Subject: Suwannee American Cement Company
Response to Requests for Additional Information
DEP File No. 1210465-001-AC (PSD-FL-259)

ADDITIONAL INFORMATION

**IN SUPPORT OF
AN APPLICATION FOR A PSD
CONSTRUCTION PERMIT
REVIEW**

**DEP File No. 1210465-001-AC
PSD-FL-259**

Mechanical Process Flow Sheet
PREHEATER, KILN AND COOLER

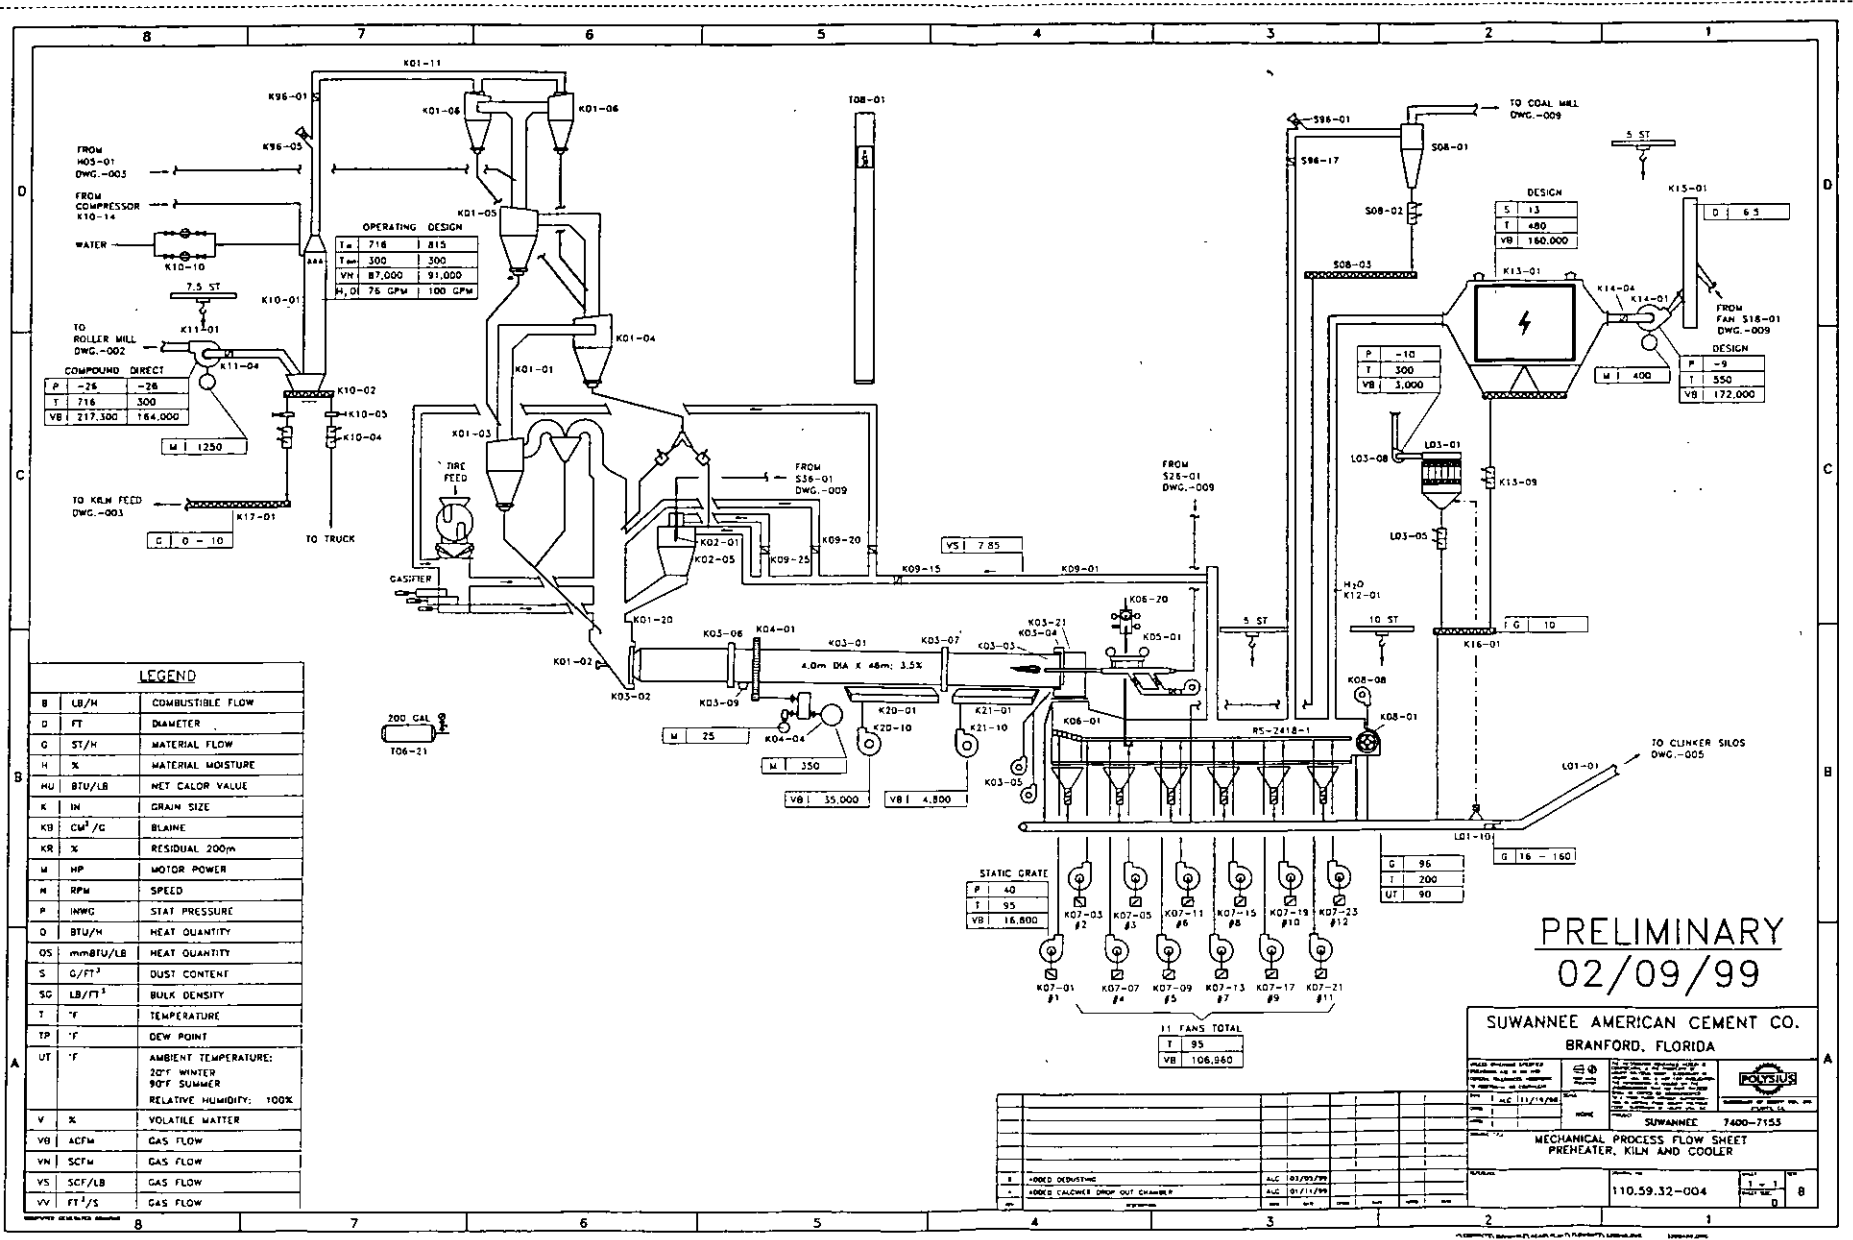
- 7
3. Please finalize the design of the particulate control devices for the in line kiln/raw mill and the clinker cooler and submit revised drawings that do not show the control device for the clinker cooler as "under review". Provide a description of the final control devices selected, and specifications for each device.

Particulate matter emissions from both the kiln/raw mill system and the clinker cooler will be controlled by electrostatic precipitators. Identical precipitators will be used at the two locations. The description and technical specifications of a precipitator sized for this specific application by Environmental Elements Corporation is with this response. This precipitator or an equivalent precipitator will be selected by Suwannee American.

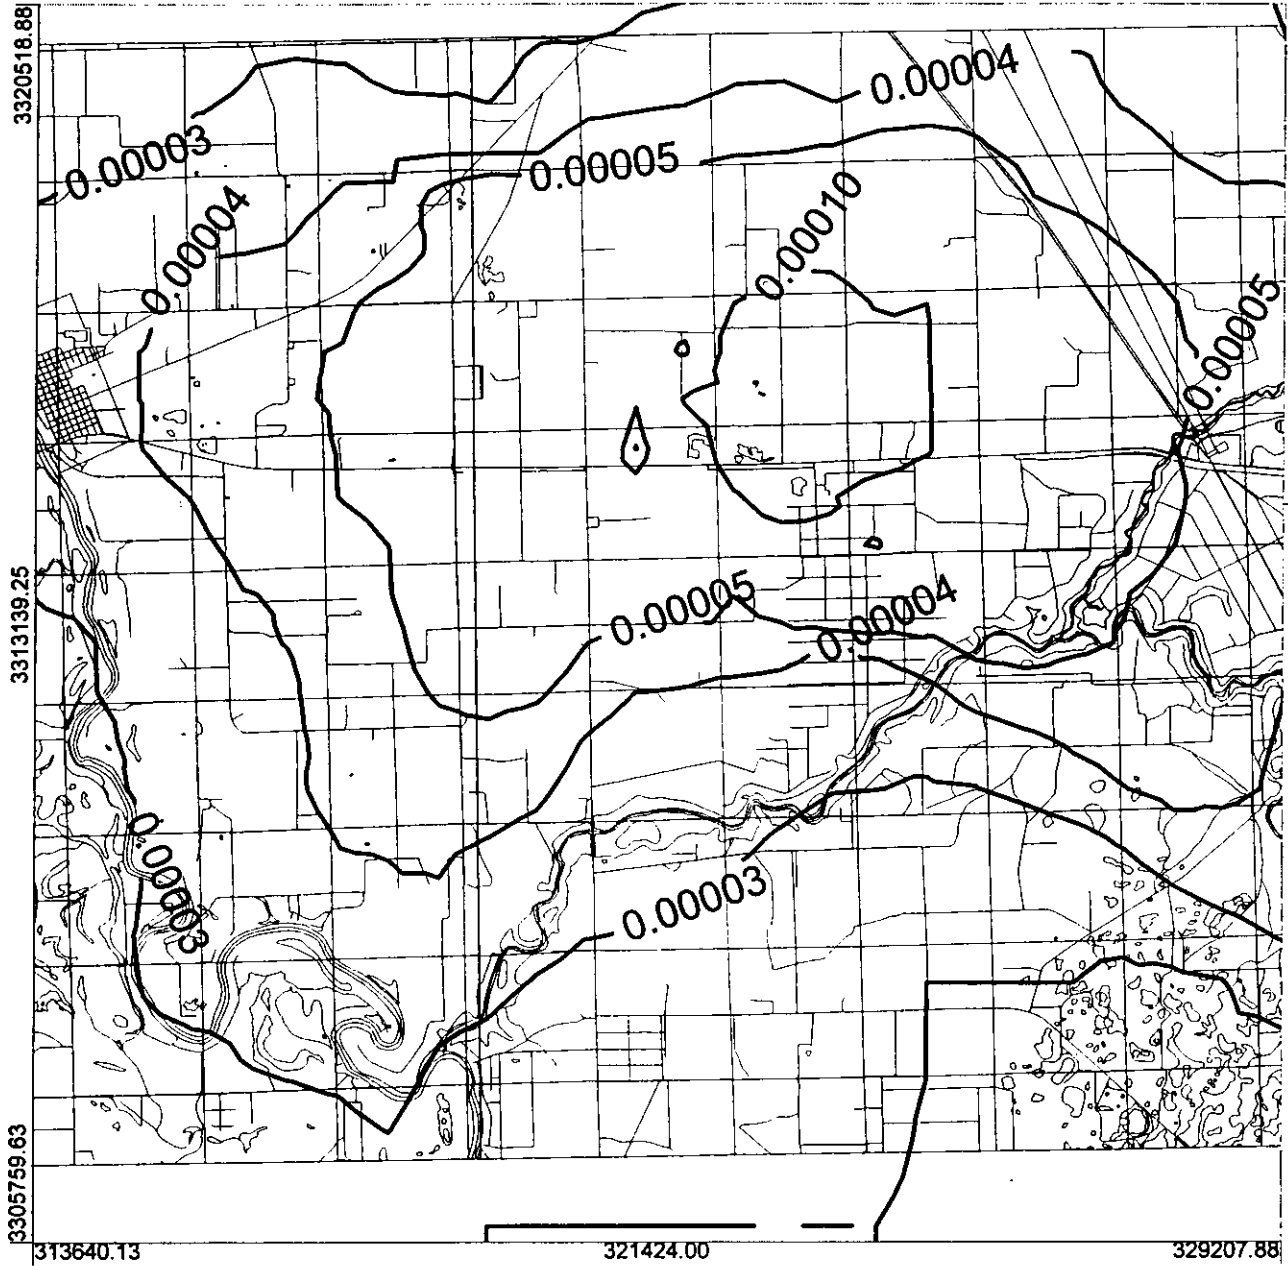
13. Please discuss the basis for the estimated emissions of mercury and provide illustrative calculations. Please estimate the possible impact or deposition of mercury at the Ichetucknee Springs State Park and the Santa Fe and Suwannee Rivers in the vicinity of the proposed facility.

Emission estimates based on expected mercury levels in limestone, clay, sand, fly ash, and coal that will be used by Suwannee American result in an estimated emission rate of 129 pounds per year

The ambient air impact of mercury at the Ichetucknee Springs State Park and the Santa Fe and Suwannee Rivers in the vicinity of the proposed facility is estimated as 0.00003-0.00005 $\mu\text{g}/\text{m}^3$ as a maximum annual concentration. The Reference Air Concentration (RAC) for mercury (40 CFR 266, Appendix IV) is 0.3 $\mu\text{g}/\text{m}^3$, annual average.

PROJECT NAME:
FENCELINE RECEPTORS
Plant Components

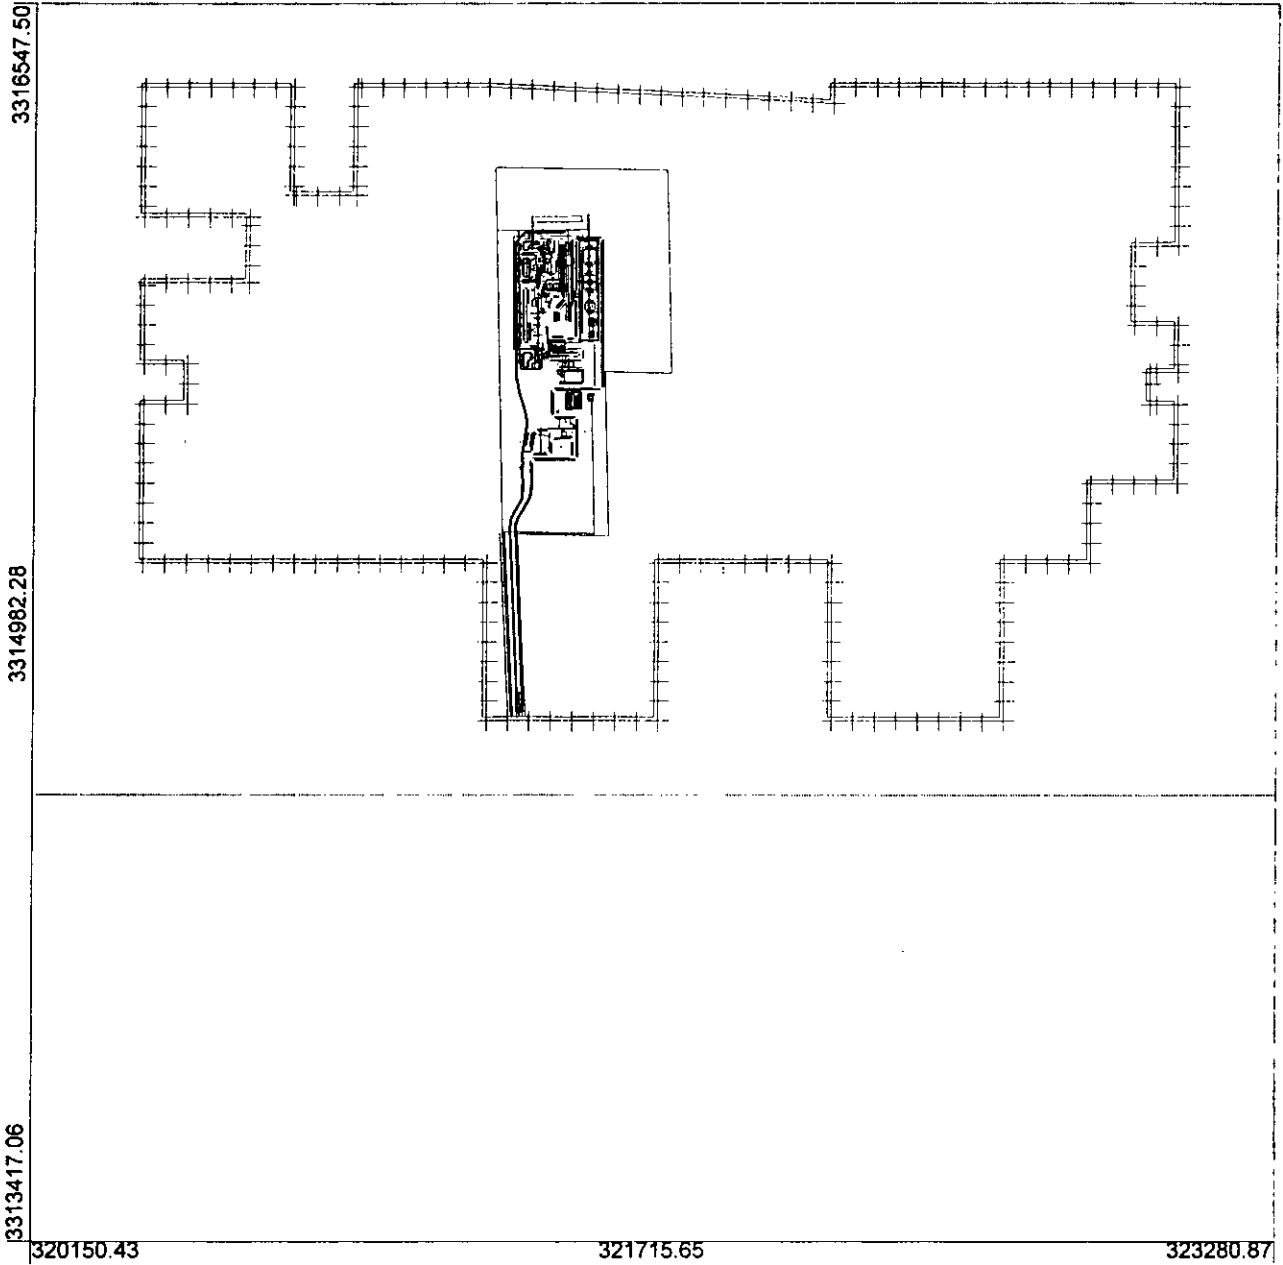
16. The PSD application does not contain discussions of the modeling procedures, selected model options, source emission information, and receptor information associated with the area of significance, PSD increment, and NAAQS modeling. This information is needed to adequately understand the modeling results presented in the application. In addition, please provide a detailed map showing the location of all of the fence-line receptors used in the air quality impact analysis. These receptor locations should be shown in the coordinate system used in the modeling. This detailed map should also display the location and dimensions of the various plant components.
